**CITY OF RIPLEY
JACKSON COUNTY, WEST VIRGINIA**

**PHASE II – PROPOSED SANITARY SEWER SYSTEM IMPROVEMENTS PROJECT
CONTRACT #3 – PROPOSED 1.2 MGD WASTEWATER TREATMENT PLANT**

ADDENDUM #2

MARCH 23, 2022

SHEET No.
51

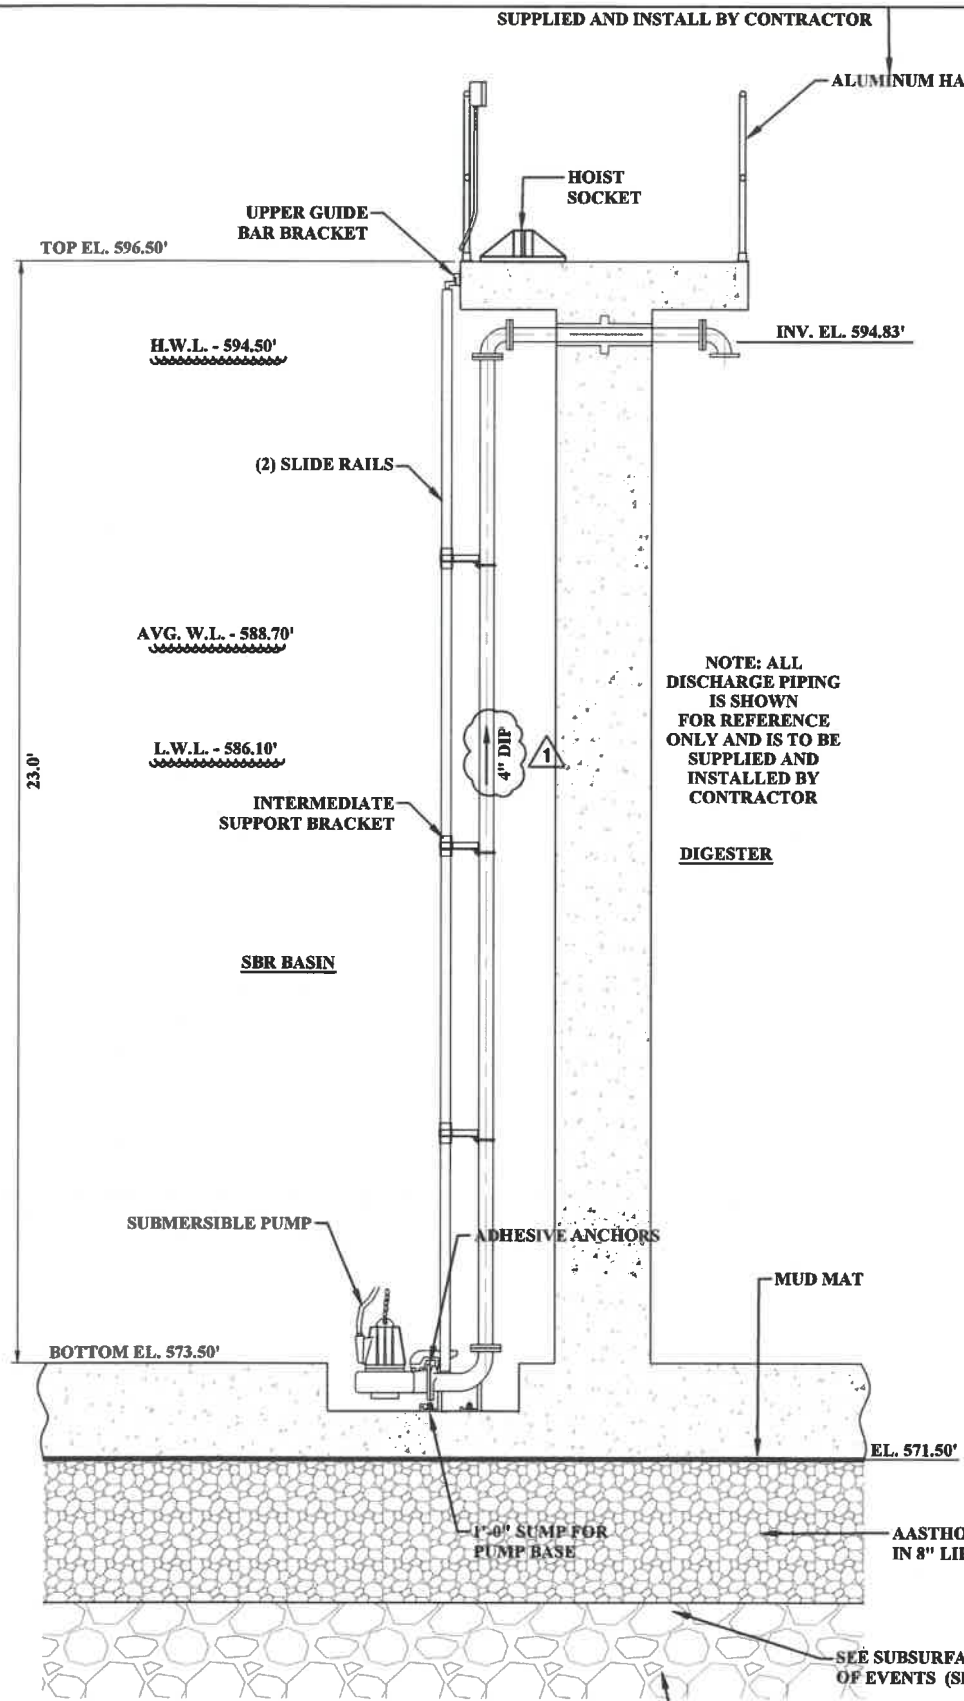
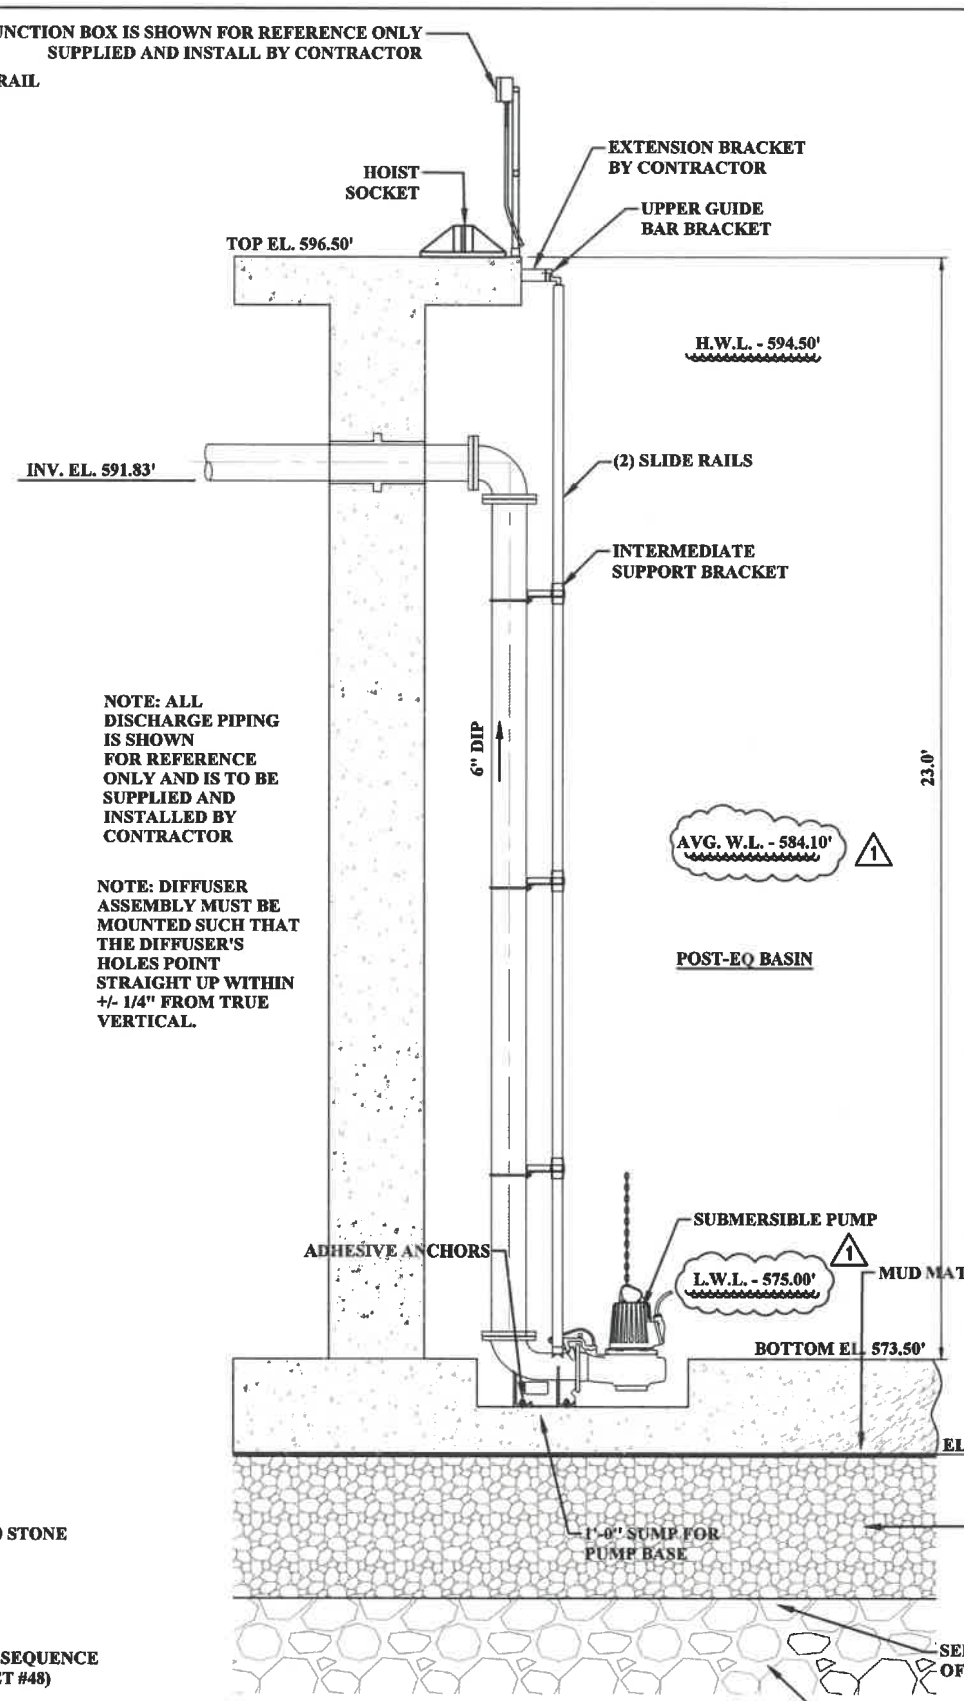
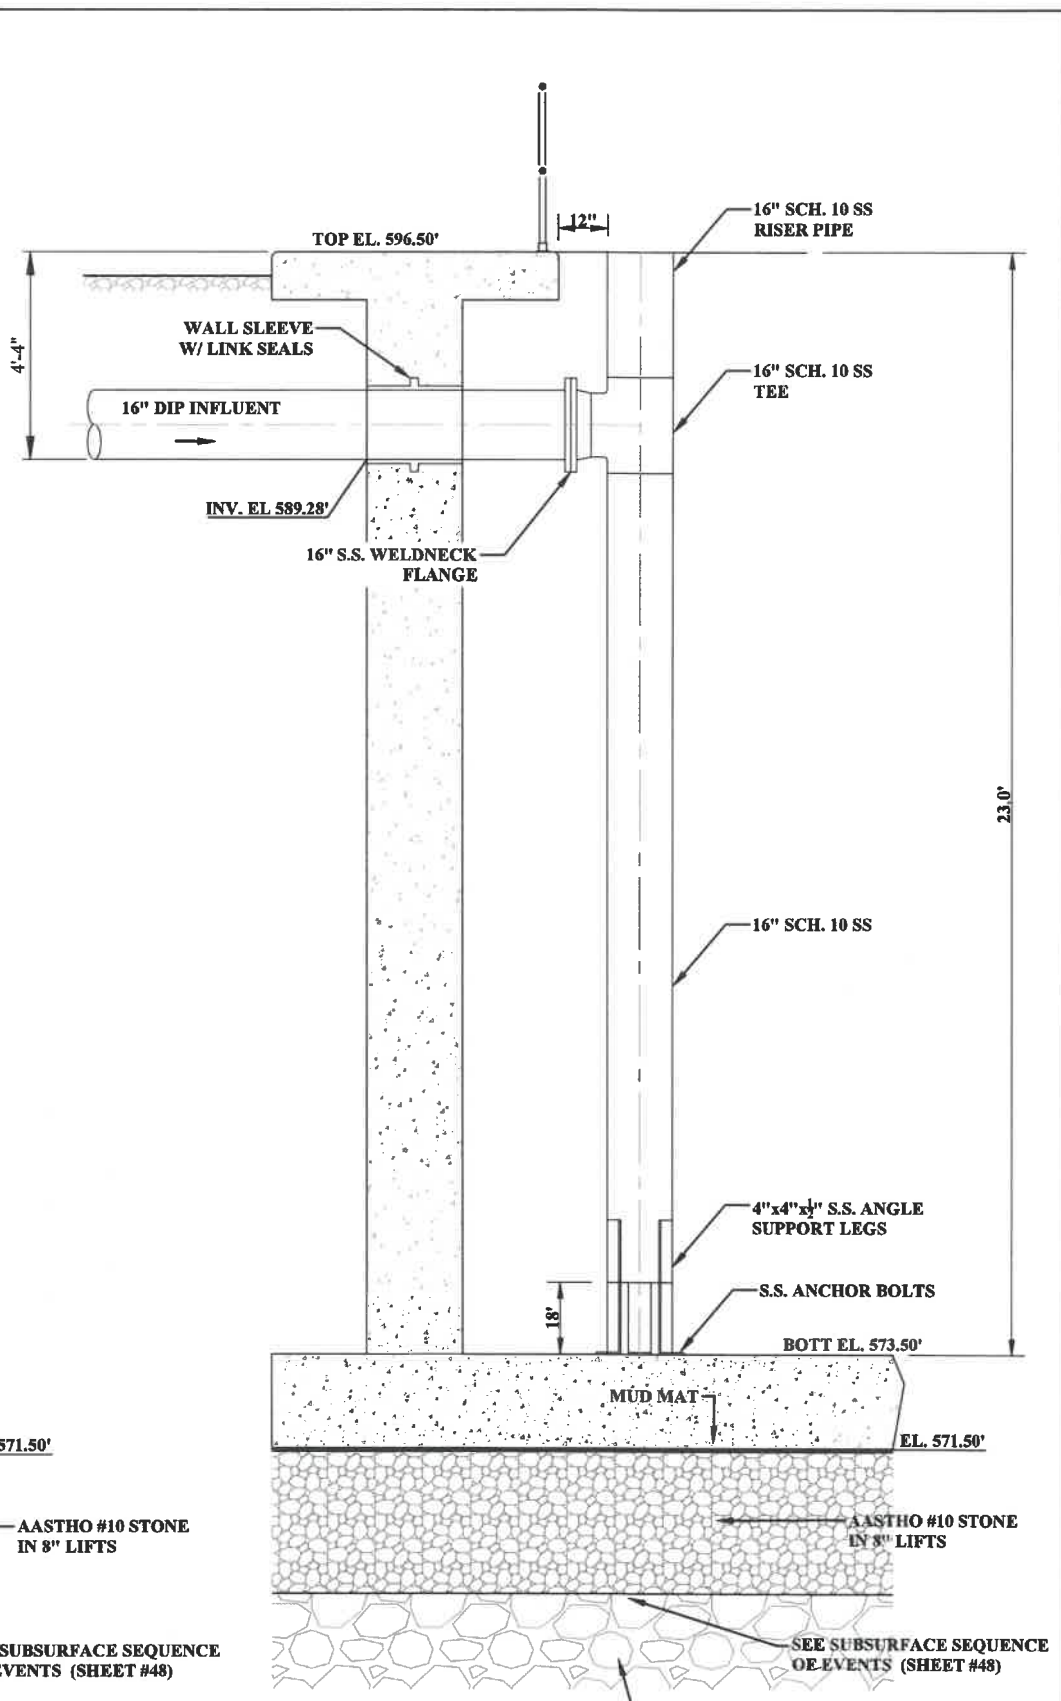
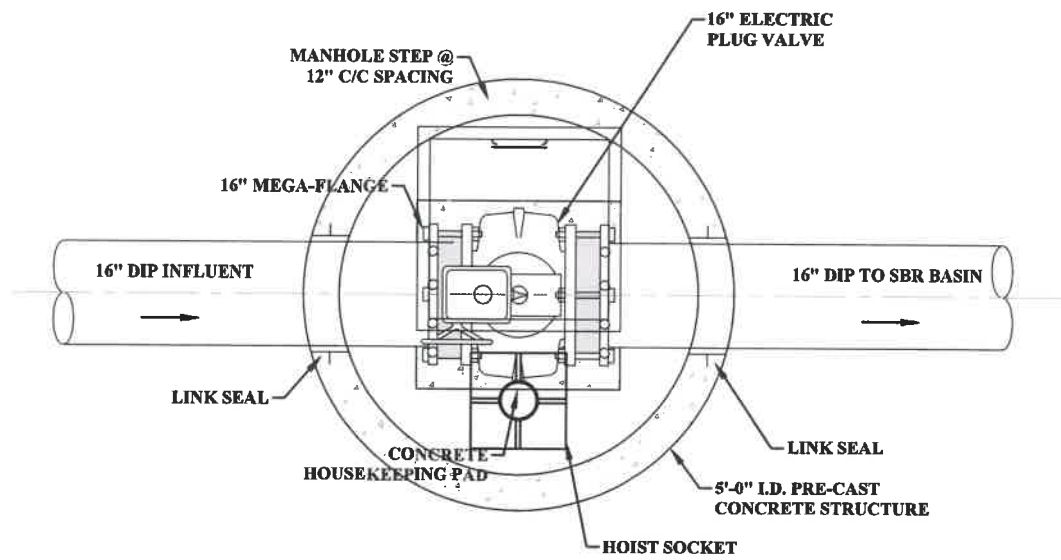
4. Sheet 49
 - a. Centerline of decant pipe adjusted to 11.1’ to reflect Specification 461405.
5. Sheet 51
 - a. Post-EQ water levels have been corrected.

- b. SBR sludge discharge pipe has been revised to 4” DIP instead of 3” DIP.
6. Sheet 52
 - a. Note added to clarify the sludge feed line pump will be supplied by the Contractor, as detailed in Specification 333220.

SHEET No.	52
-----------	----

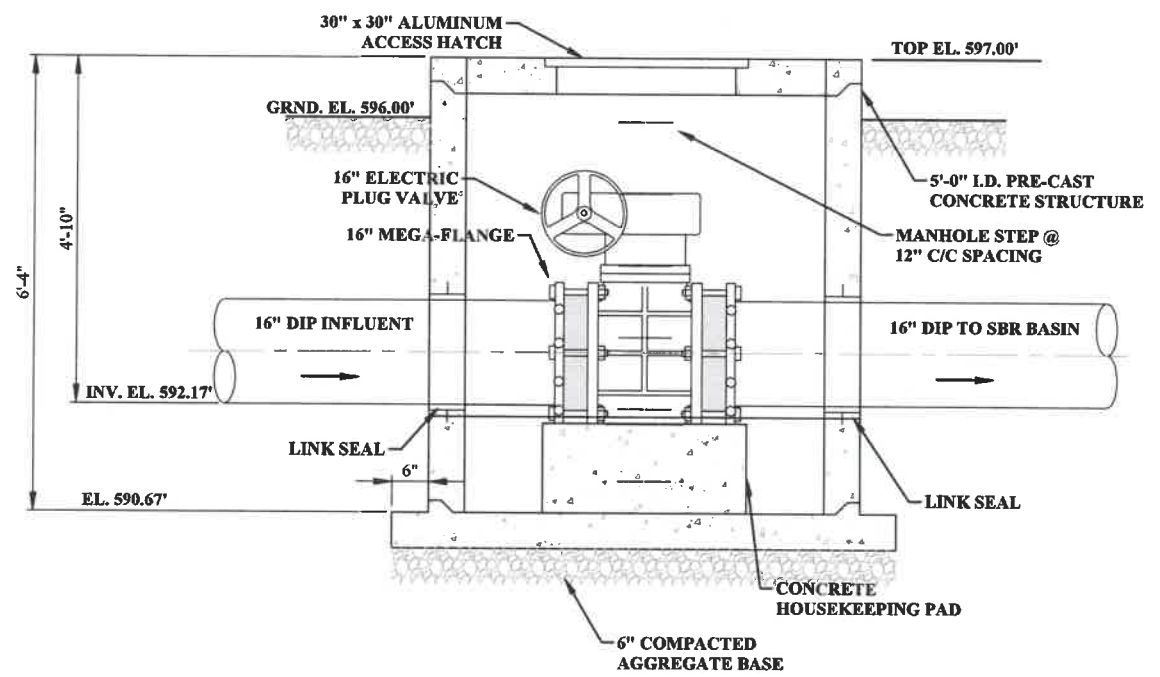
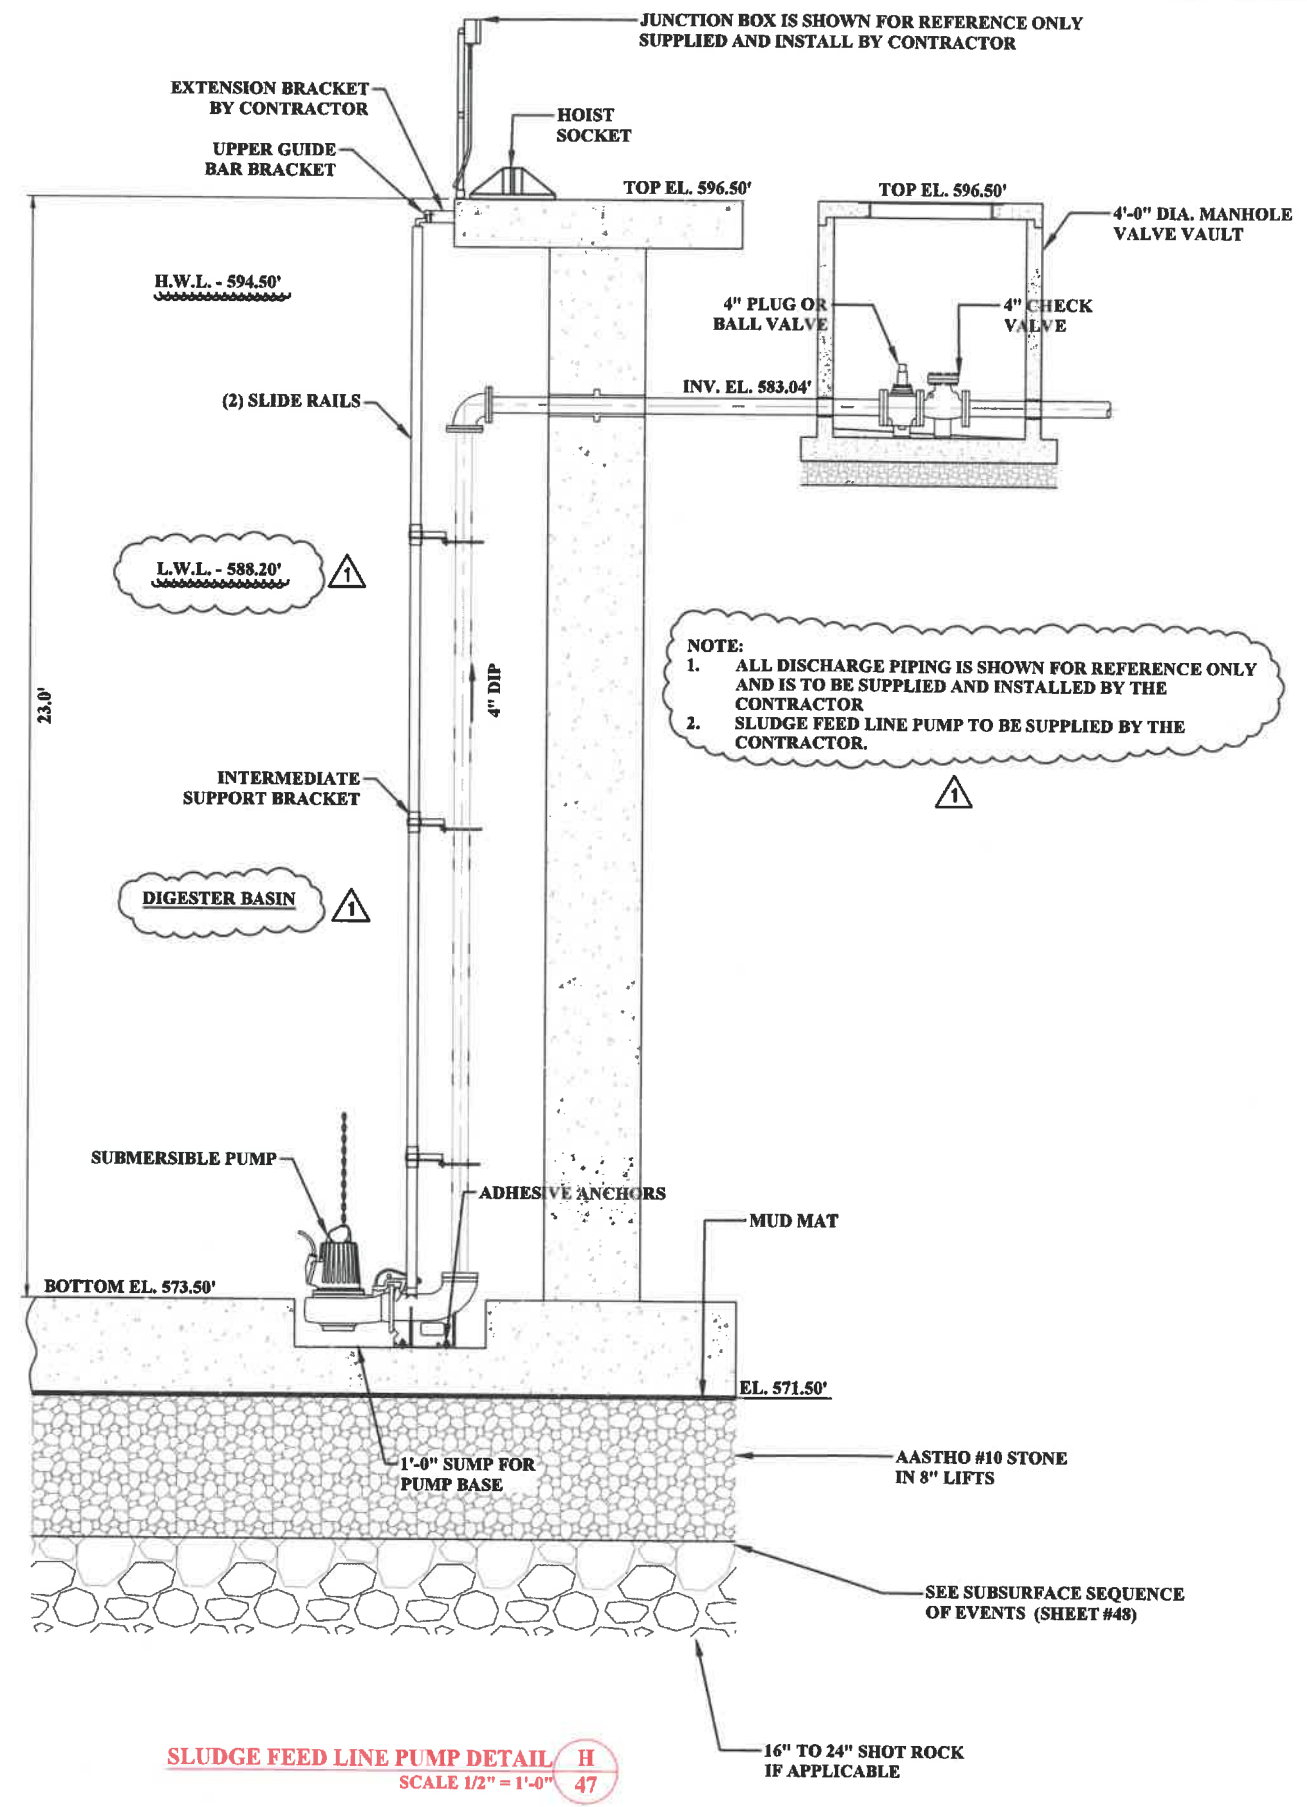
- b. Revised mis-labeled basin.
 - c. Water levels for the digester basin have been revised.
7. Sheet 53
 - a. Note added to clarify the digester decant pump and pump hoist will be supplied by the Contractor, as detailed in Specification 333220.

CITY OF RIPLEY
 PROPOSED 1.2 MILLION GALLONS PER DAY
 WASTEWATER TREATMENT PLANT
 SBR TREATMENT SYSTEM
 SBR INSTRUMENT DETAILS

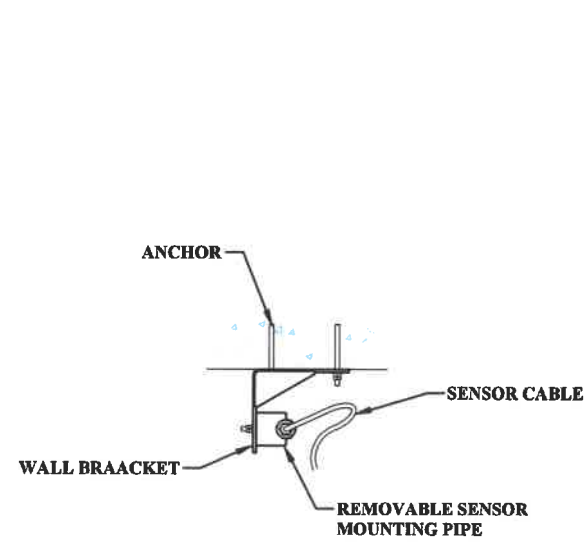
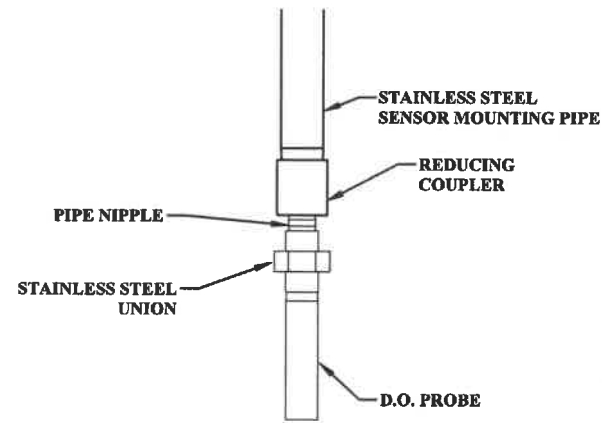
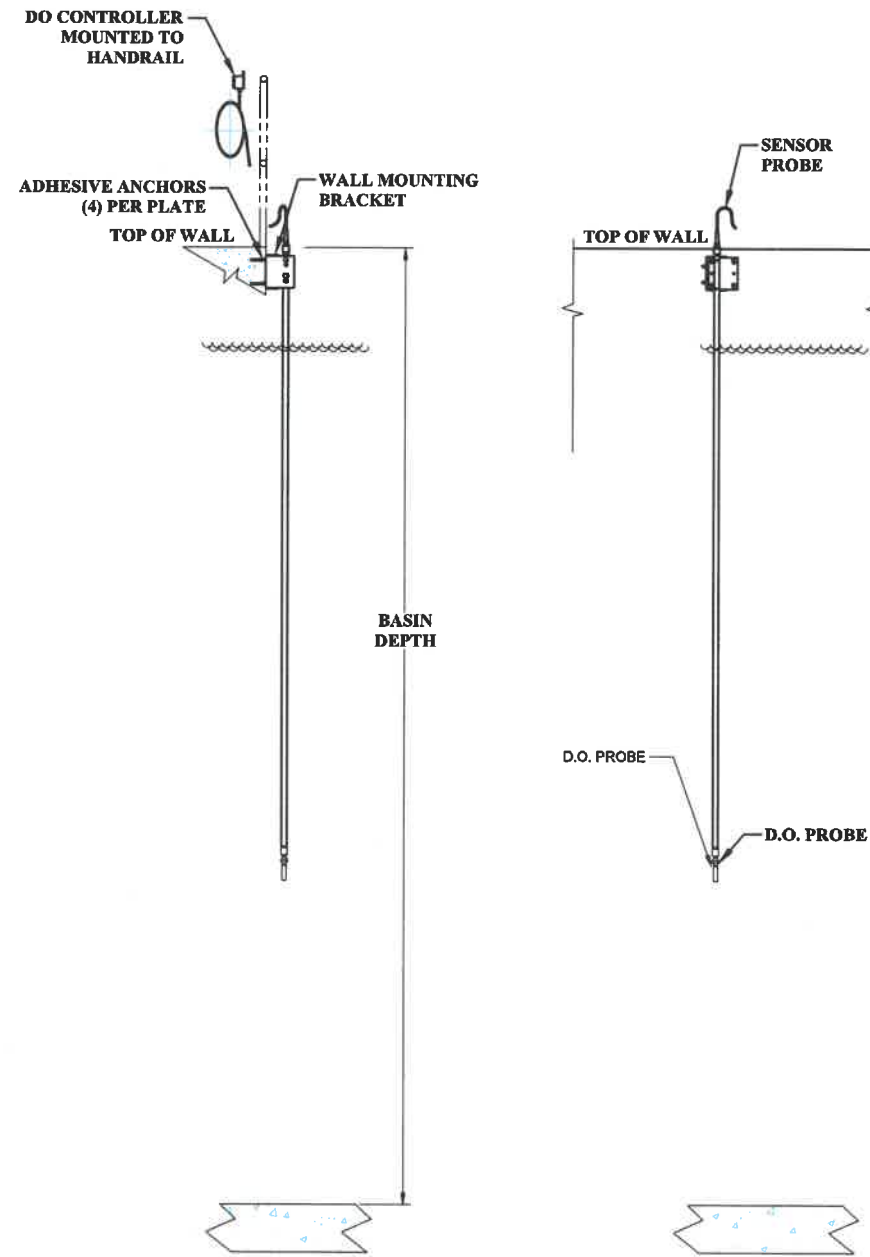
8. Sheet 56
 - a. DO sensor details have been revised. The old plan sheet depicted Thermo Fisher DO sensors; however, the basis of design was Hach DO sensors. Hach is named in Specification 461405. The page now depicts Hach DO sensors.
